NEIGHBORHOODS, INC.
MADISON, WISCONSIN

July 27, 2018

Re: 122 State St. Hotel Proposal

Figure: Hotel Skyline Rendering provided to the Steering Committee

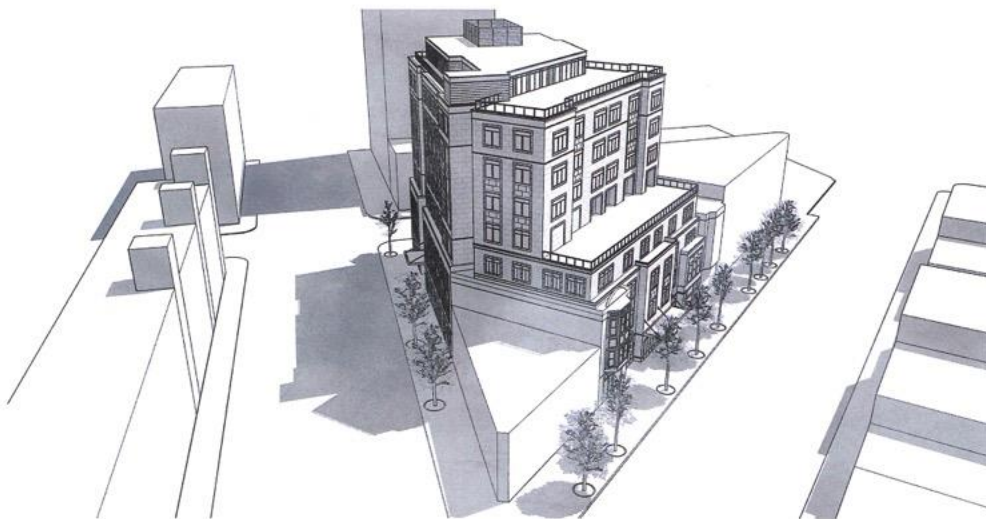
* **Architectural Enhancements:** The current design for the "122 State Street Project", shared with the Steering Committee at our June 14 meeting, is well-thought-out and attractive. In fact, its visual and vertical articulations actually complement the existing downtown skyline adjacent to the Dayton – Carroll Street intersection, as well as the established building height along its State Street aspect. (See Figure.)

Because this building, as proposed, so well complements the existing downtown skyline, we have NO PROBLEMS/CONCERNS regarding its height. This proposed hotel is positioned to be a shining beacon of culture and urbane energy on Upper State, so let it be higher than usual; it’s exactly the type of development that Madison should be emphasizing.
